Applies To: **2000-01 S2000** – ALL
2002 S2000 – From VIN JHMAP1...2T000001 thru JHMAP1...2T006983

July 10, 2002

Product Update Campaign: S2000 Spark Plugs

2000 and 2001 Owner's Manuals, page 175:
2002 Owner's Manual, page 181:

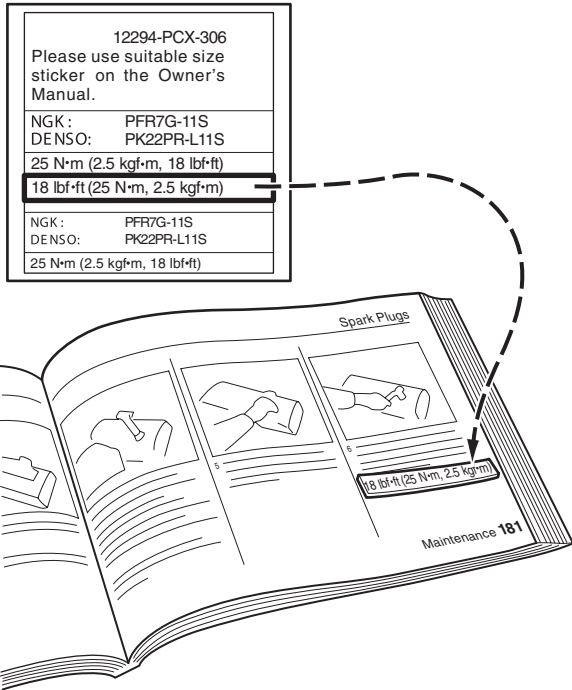
7. Peel off the appropriate correction labels, and stick them on the S2000 Owner's Manual pages as shown.
